VOLUNTARY RECALL LEW ELECTRIC PART #PUFP-B

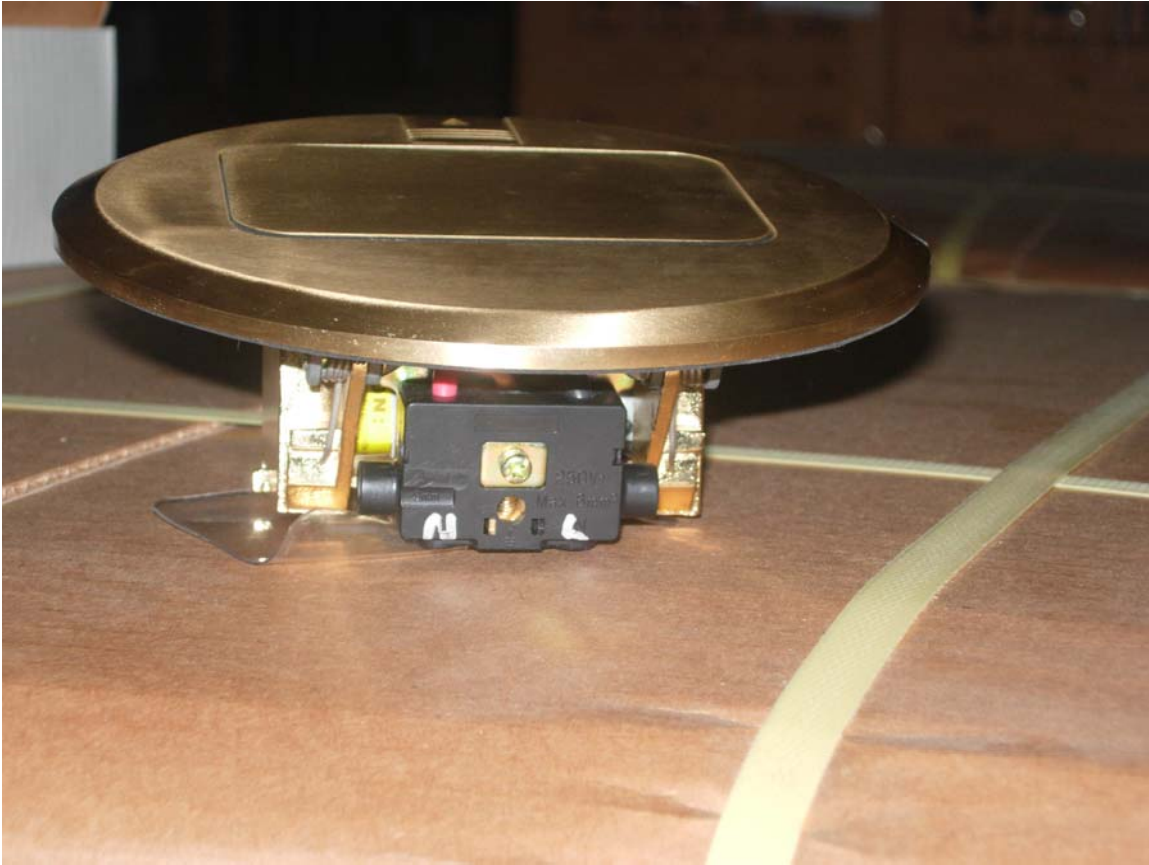
Any items purchased prior to April 4, 2007 have reverse polarization to the wiring device. The factory has made visible markings (as shown above) to identify which wires are connected to the load (L) and the neutral (N) terminals to correct the problem. Items purchased prior to this date may be returned for an exchange by contacting the factory at: 708-345-2075 X23 or visit our website at www.lewelectric.com under “Contact Us”

Items purchased after this date that contain these markings are ready for use and need no return. The factory will give specific instructions for the exchange if a return is requested. An item bought prior to the April 4 date that has not been installed can be changed by marking the black terminal exactly as shown above in permanent metallic silver marker, if a return is deemed unnecessary.
